Mapleton City

City Council Staff Report

Consideration of a Resolution approving the Final Plat for the Walter Farms Subdivision Plat "A" consisting of thirty one lots located at 800 North and 300 West, Rezone from A-2 to RA-1, and the application of a TDR-Receiving Site Overlay Zone.

June 30, 2015
DRC Comments

PLAT "A"
WALTER FARMS
SUBDIVISION

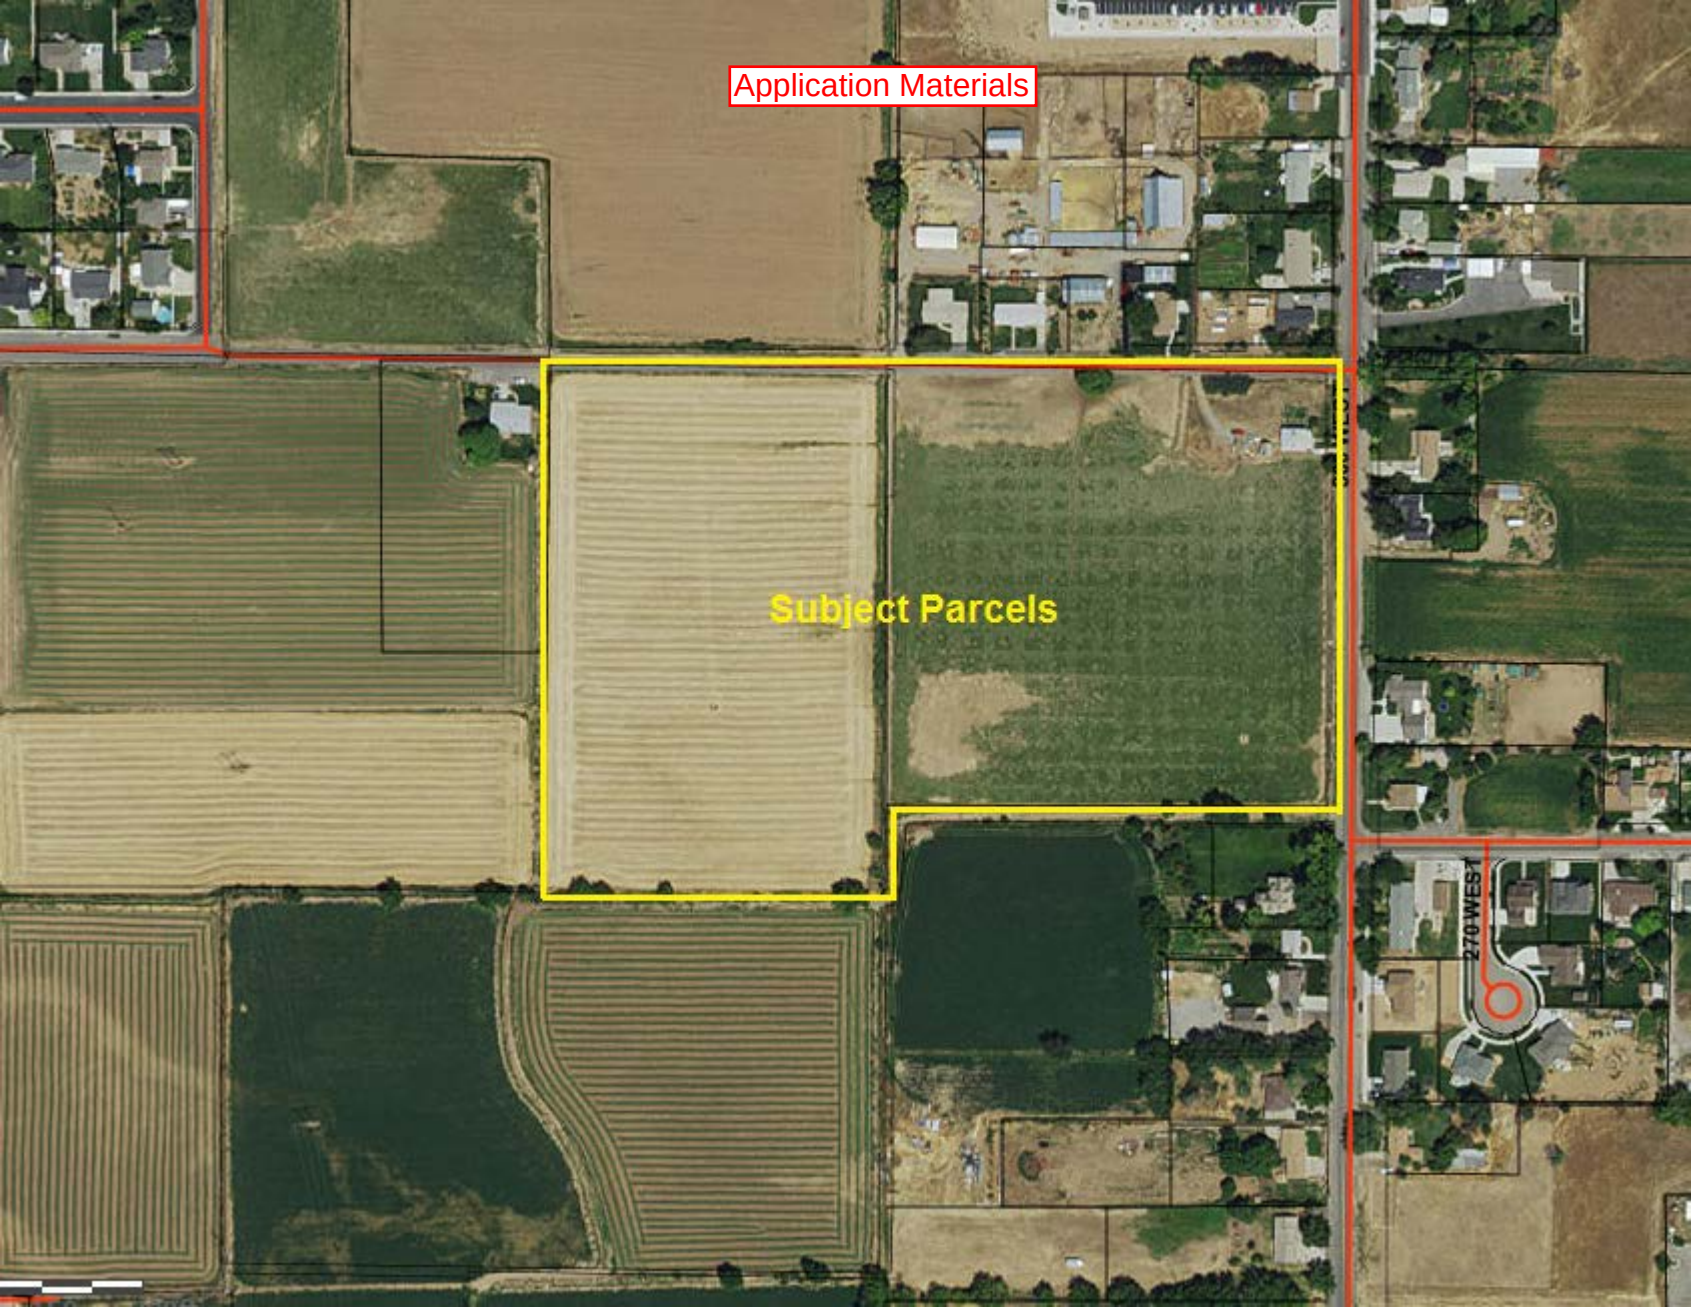
1. Please place the assigned addresses on the final plat (Final page of this document).
2. Please include a line for the notary to print their full name, their commission number and the words "A notary public commissioned in Utah" in the notary public signature block. This is a precaution to prevent issues with illegible notary stamps.

Miscellaneous:
1. Receive irrigation company approval for work on Mapleton Irrigation Company ditches
2. Power poles will need to be removed on 800 North and 300 West.
3. Mapleton/APWA standards.
4. Granular borrow required in all trenches and fill areas.
5. Plat page shows 300 West with 66' wide R/W this should be changed to 56'.

WALTER FARMS PLAT"A" SUBD.
RICHARD WALTER
STREET CROSS SECTIONS

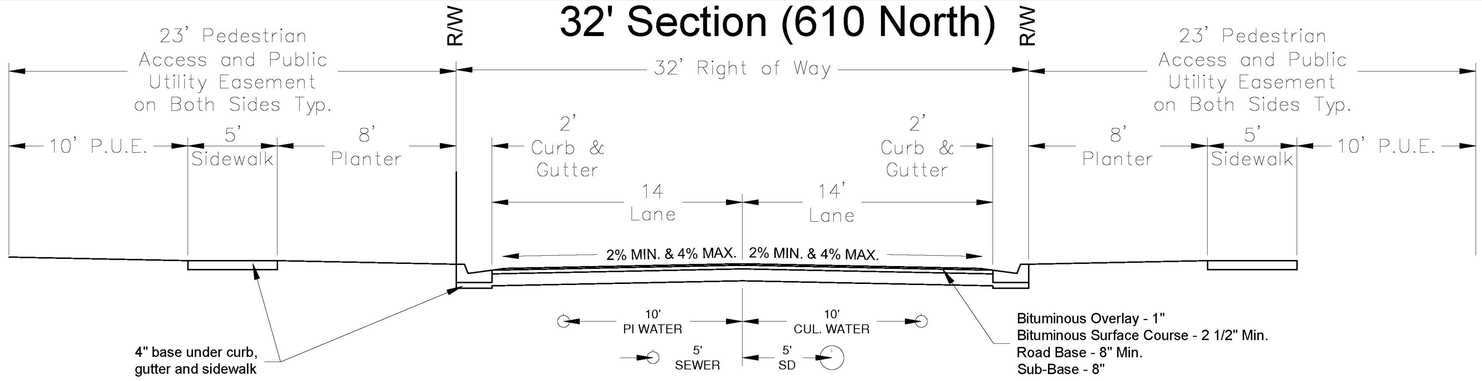
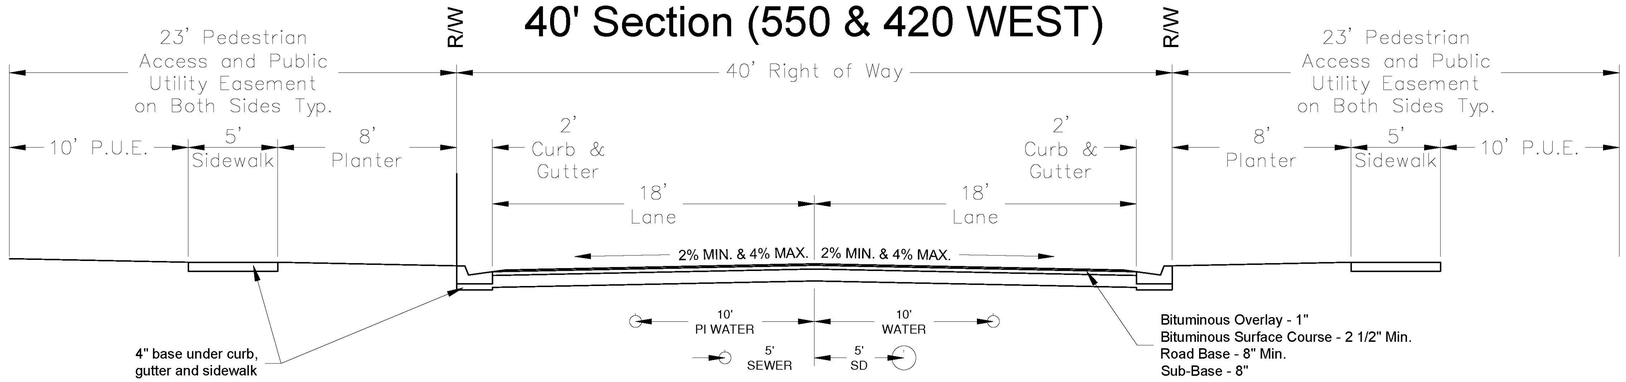
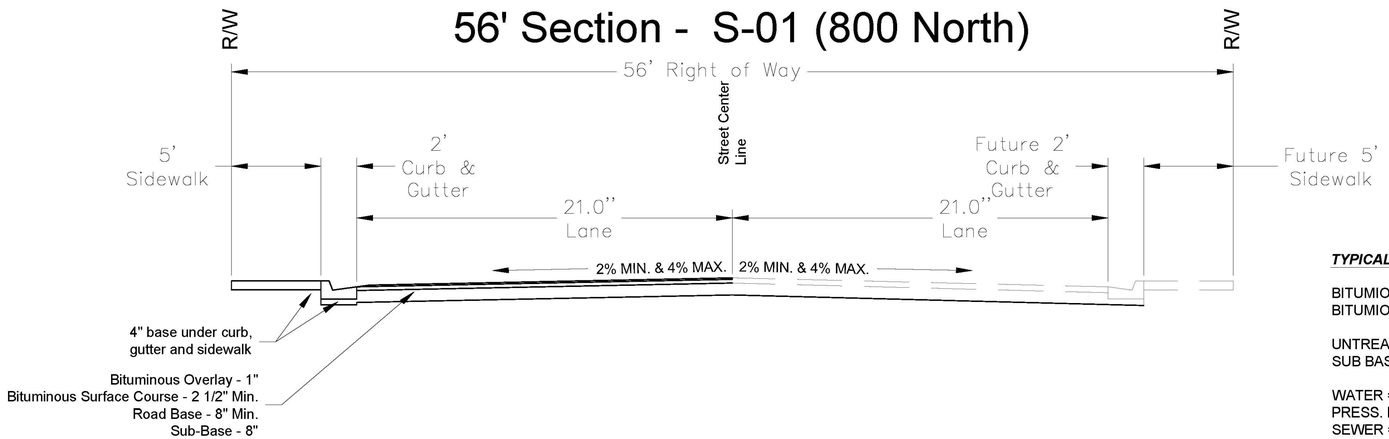
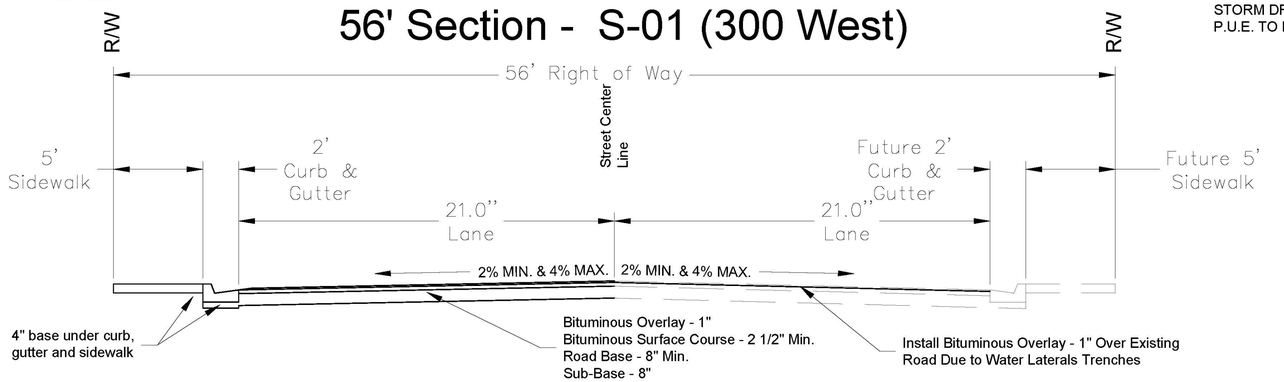
Roadway:
1. Include a 1" overlay with level course on 300 West and 800 North with multiple new utility trenches.
2. Provide information on alignment of 300 West and 800 North with regards to existing and proposed concrete improvements.
    a. (300 West may be able to shift to the east, 800 North needs to align with the west, and future improvements to north and east.)
